RE: Form 340 Application (replacement)
in response to FCC letter 1800B3-EPD

APPLICATION FOR CONSTRUCTION PERMIT FOR
NONCOMMERCIAL EDUCATIONAL BROADCAST STATION
(Carefully read instructions before filing form) Return only form to FCC

ENGINEERING STATEMENT

The attached Engineering Data is submitted herewith in support of an application by WPKN Inc., Bridgeport, Connecticut for a Modification of Construction Permit, File No. BPED-881212IC, and in response to a Commission Letter to WPKN Inc. - Re: 1800B3-EPD.

INTERFERENCE STUDY
 Radio Station WPKN
 Bridgeport, Conn
 89.5 mcs, 9 Kw. ERP DA

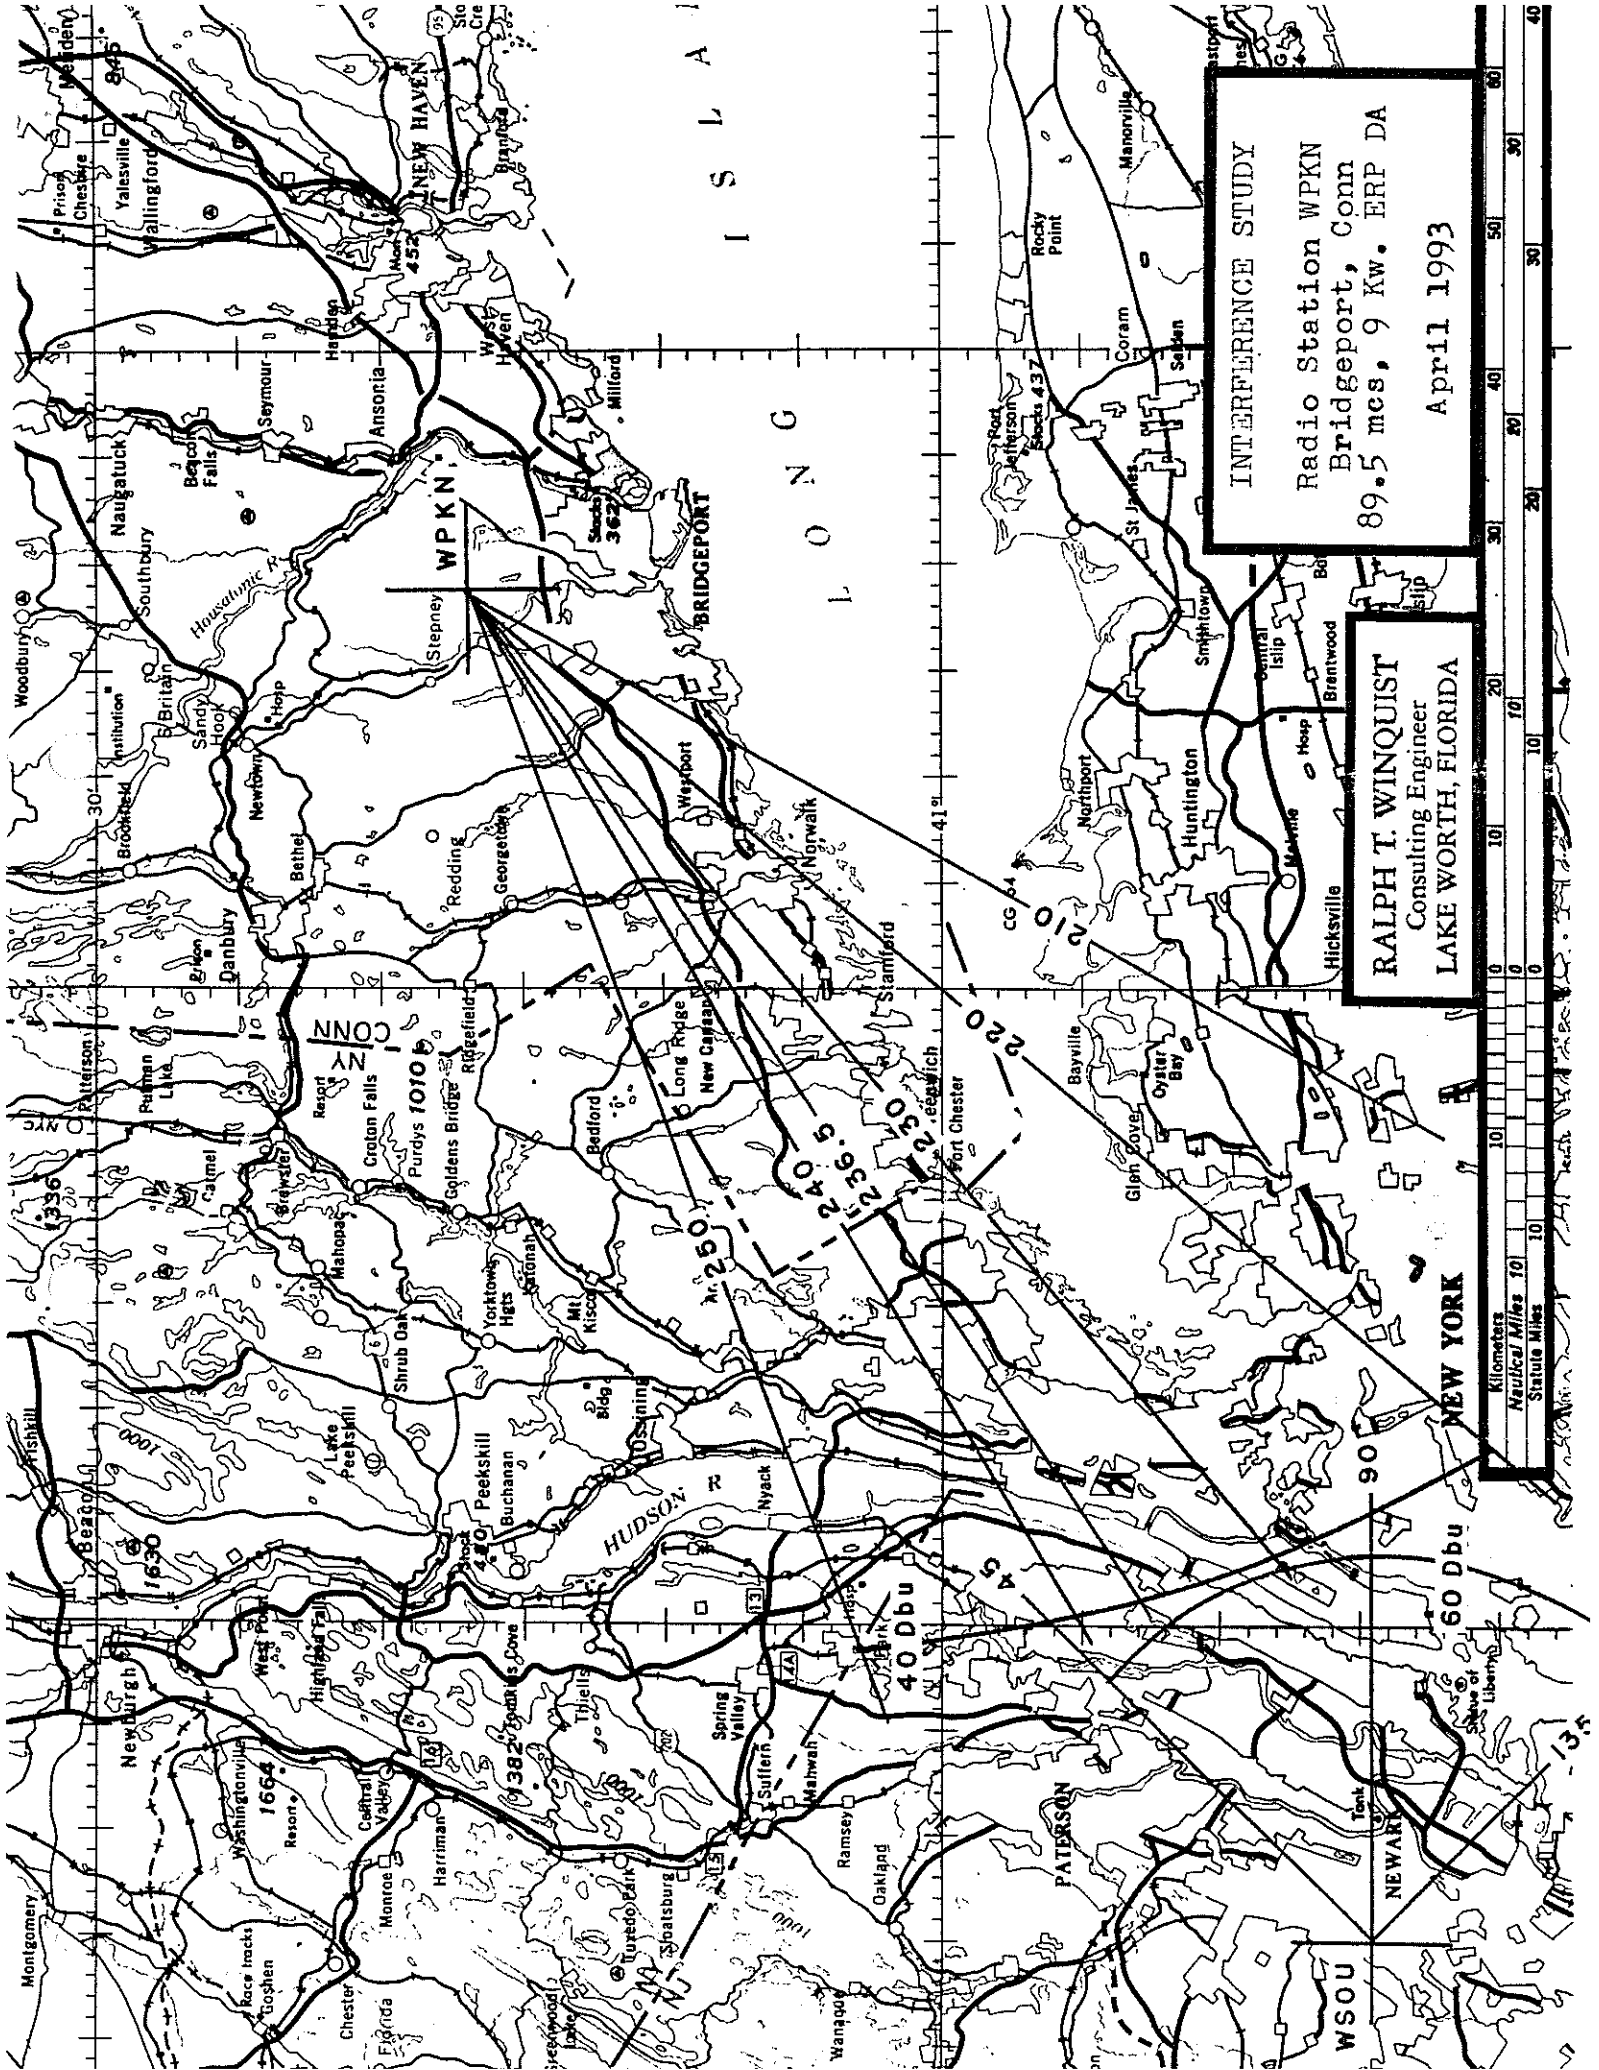
Commission Staff reports "Excessive radiation to the southwest causes interference to Station WSOU(FM), South Orange, N. J.". While this radiation is in excess it amounts to only a few percent increase. Had not WSOU been granted a power increase there would have been no overlap -- nowhere either in the WSOU Engineering File nor the Commission response to the initial request for 2.8 Kw ERP is there any mention that consideration was given to the possible overlap of the WSOU 60 Dbu contour by the valid outstanding WPKN Inc. Construction Permit at either the 2.8 Kw or the 2.4 Kw level suggested by the Commission in their response to the 2.8 Kw power increase application File No. BPED-910820IH (see attached copy of letter). This application, amended to reflect 2.4 Kw ERP was granted by the Commission on April 2, 1992. In order to remove this overlap WPKN Inc. proposes to reduce the ERP of WPKN from 10 Kw to 9.0 Kw using the new Shively Model 6015-2/3R Panel Antenna.

With the proposed reduction to 9.0 Kw ERP DA the overlap to WSOU is removed and there is at least one half mile separation between the WSOU 60 Dbu contour and the WPKN 40 Dbu contour -- thus no interference. See attached tabulation of service and interference contours along with a map showing these contours.

INTERFERENCE STUDY
 Radio Station WPKN
 Bridgeport, Conn
 89.5 mcs, 9 Kw. ERP DA
 April 1993

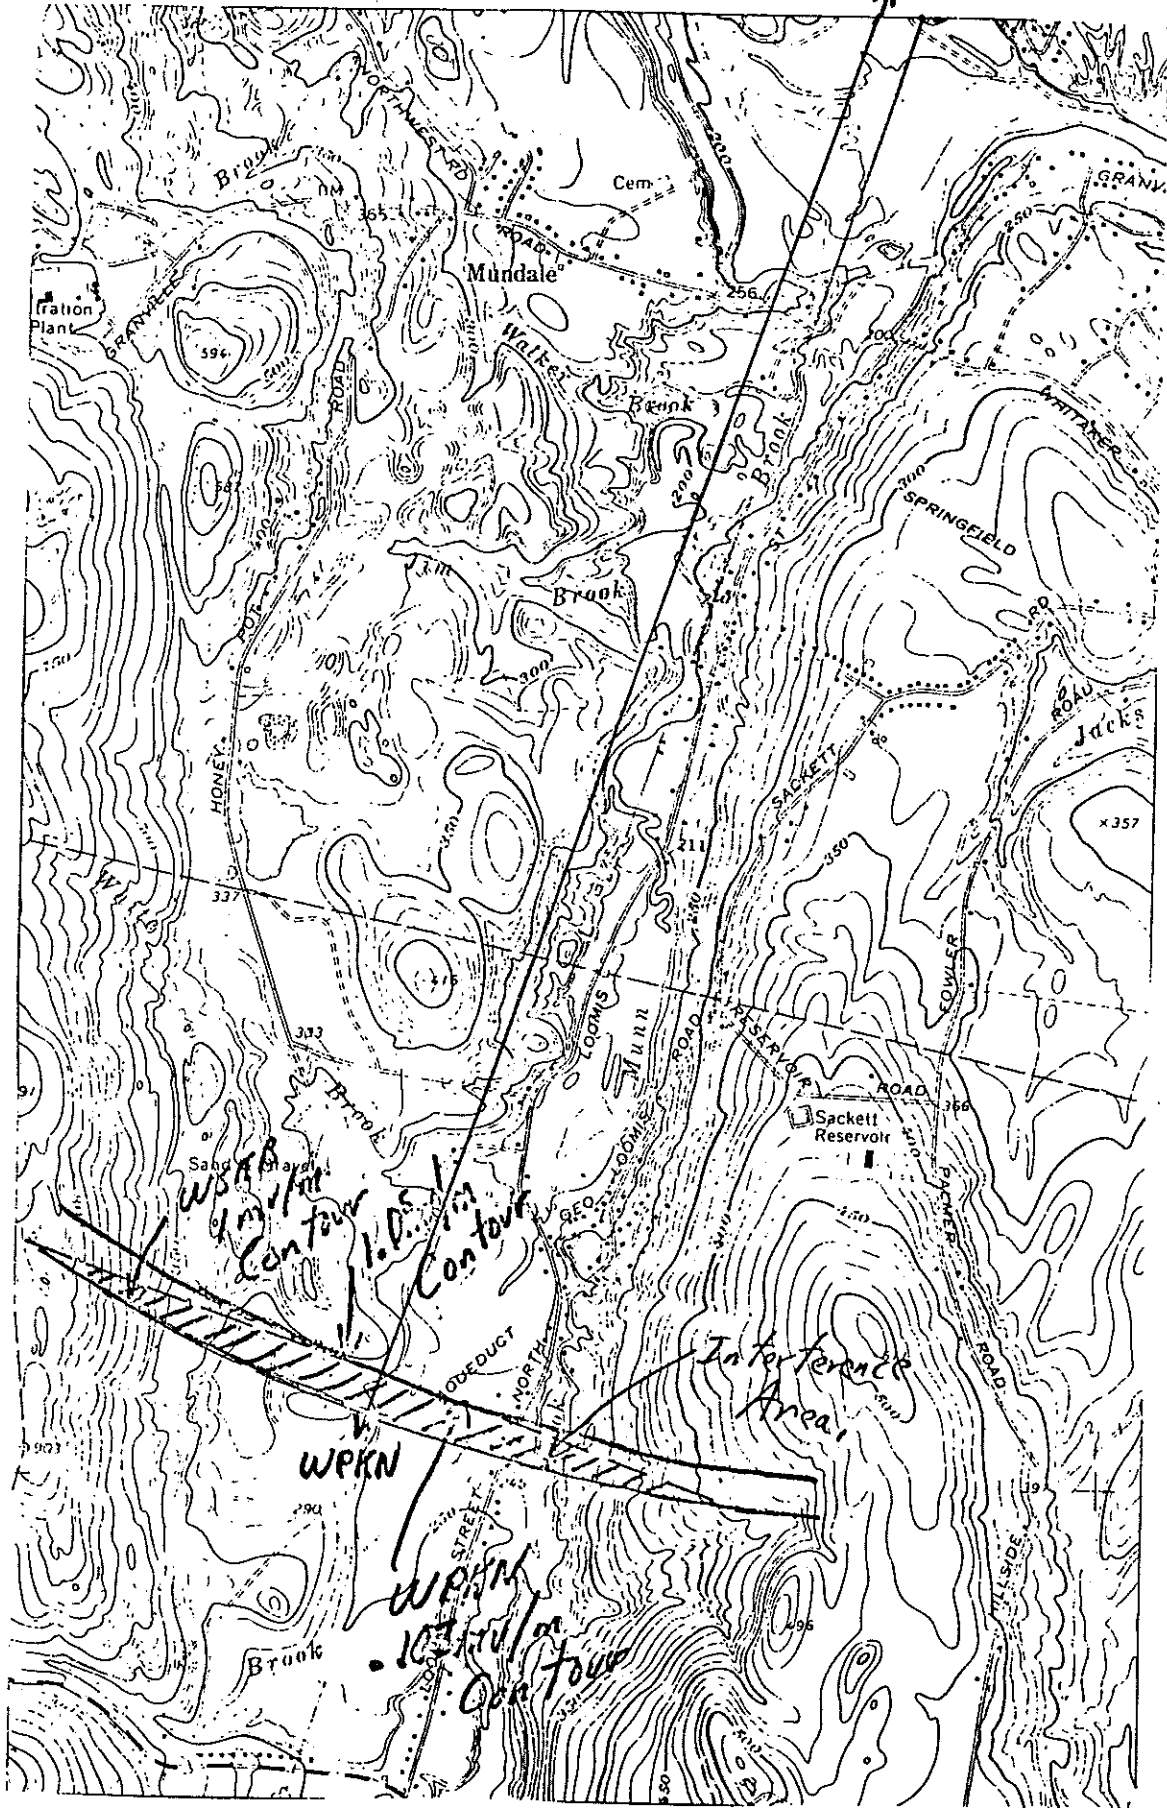
Commission Staff reports "Excessive radiation to the north causes interference to Station WSKB(FM), Westfield, Ma.". This may well be true when compared to the proposed directional antenna submitted with the application for a Construction Permit but the radiation to the north is substantially the same as the "measured" licensed directional antenna supplied by Jampro Inc. WSKB was originally a Class D and increased power to 100 watts in an application for a Construction Permit File No. BPED-791231BT and subsequently licensed, File No. BLED-830222AT. The application for a construction permit reveals that an overlap from WPKN was received and accepted in order to obtain a license -- see attached copy of a map showing this overlap as taken from the WSKB Engineering File. The reduction in power of WPKN from 10 Kw to 9.0 Kw is predicted to reduce this overlap -- see attached contour tabulation and associated map of service and interference contours.

WSKB's
 1.05 mv/m
 contour
 intersect
 WPKN's
 .105 mv/m
 contour
 as
 shown.

VERTICAL PLAN
WPKN
Bridgeport, Conn.

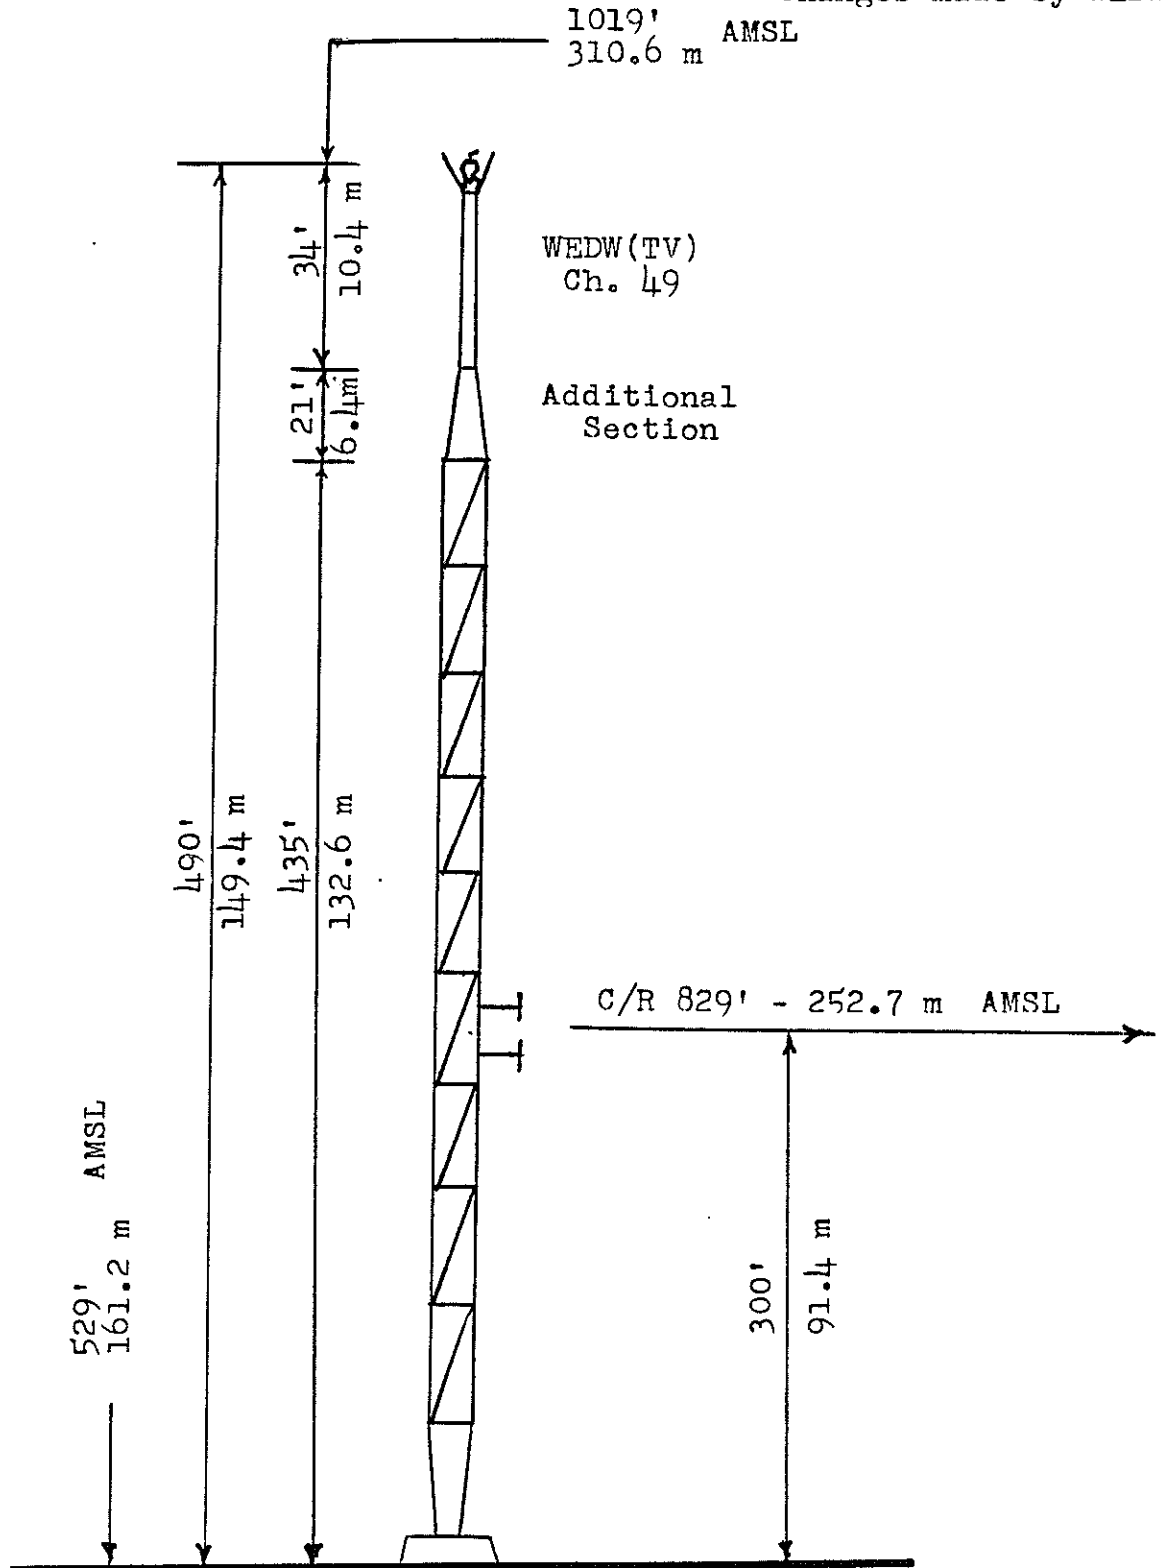
The enclosed Form 340 takes note of a pre-existing change in overall tower height above ground level which resulted from previous construction by another tenant on the tower which we occupy. It also calls for an adjustment of effective radiated power to eliminate the possibility of interference to a co-channel station. Detailed engineering data are included.

Reflects Structural
Changes made by WEDW
